## PHILADELPHIA ELECTRIC COMPANY

Subject: Peach Bottom Atomic Power Station-Units 2&3  
Mark I Containment Long-Term Program  
Plant Unique Analysis Report

Response to NRC Questions  
(Date Aug 2, 1983)

RAMSHEAD WATER CLEARING THRUST LOADS

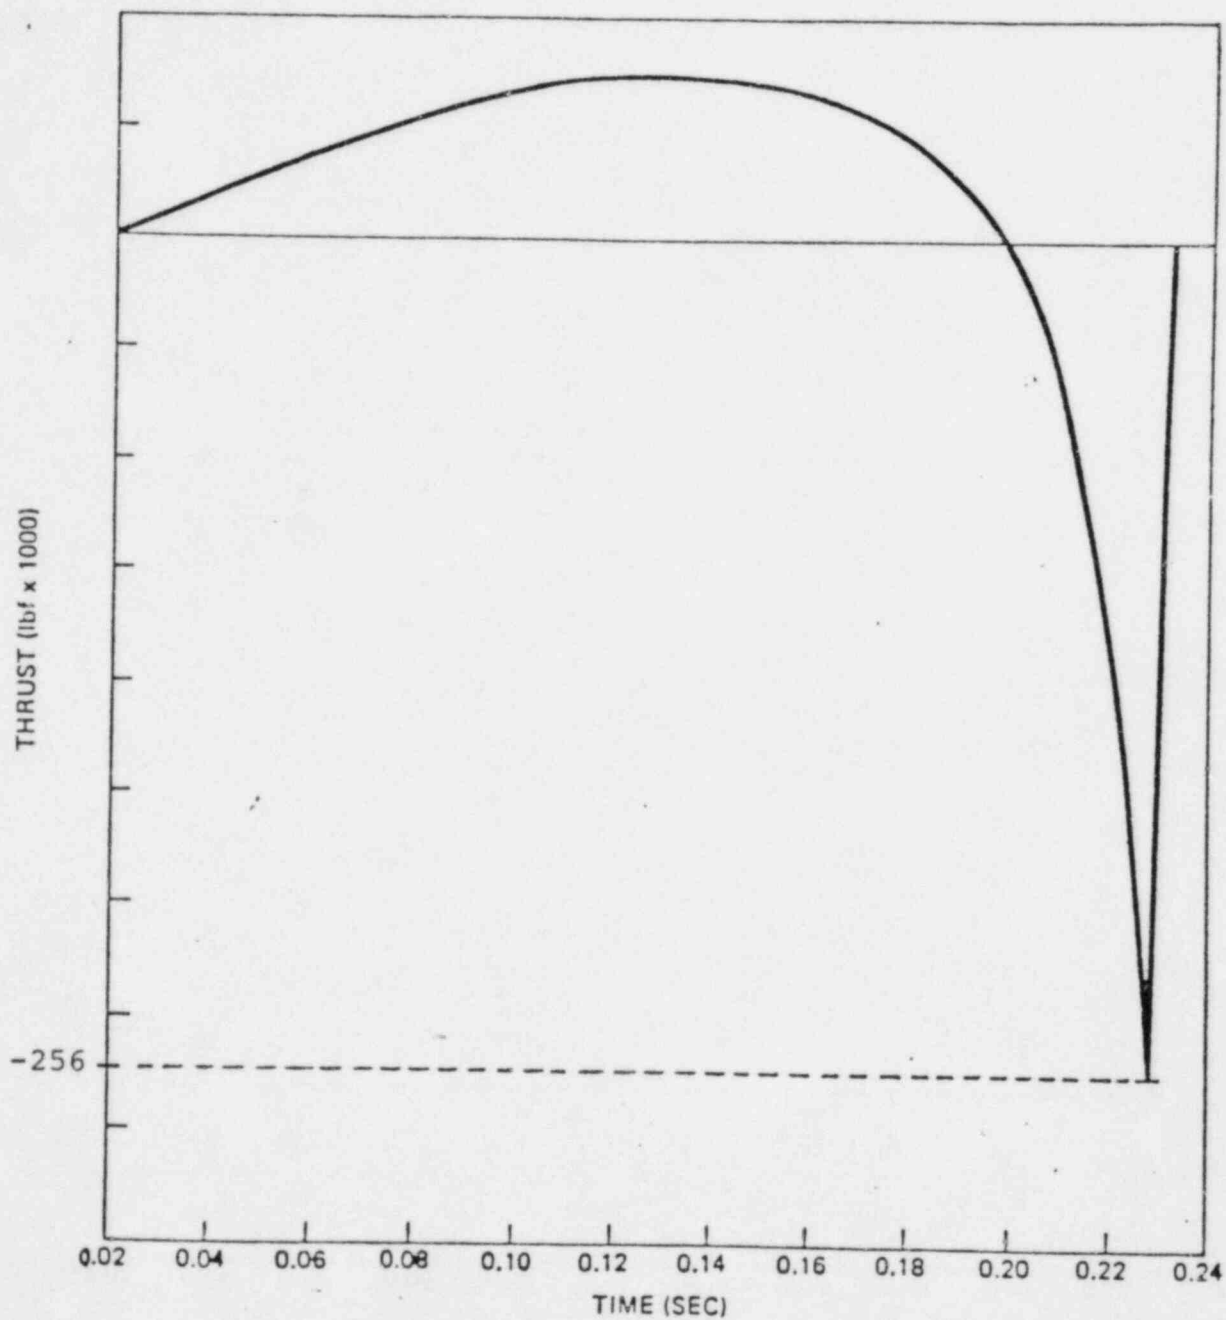
Line clearing and thrust loads on the T-quencher are not specifically mentioned in the PUAR. Were these loads calculated and what values were obtained?

The peak water clearing thrust load on the ramshhead of the T-quencher is 256 kips as shown in the attached figure.
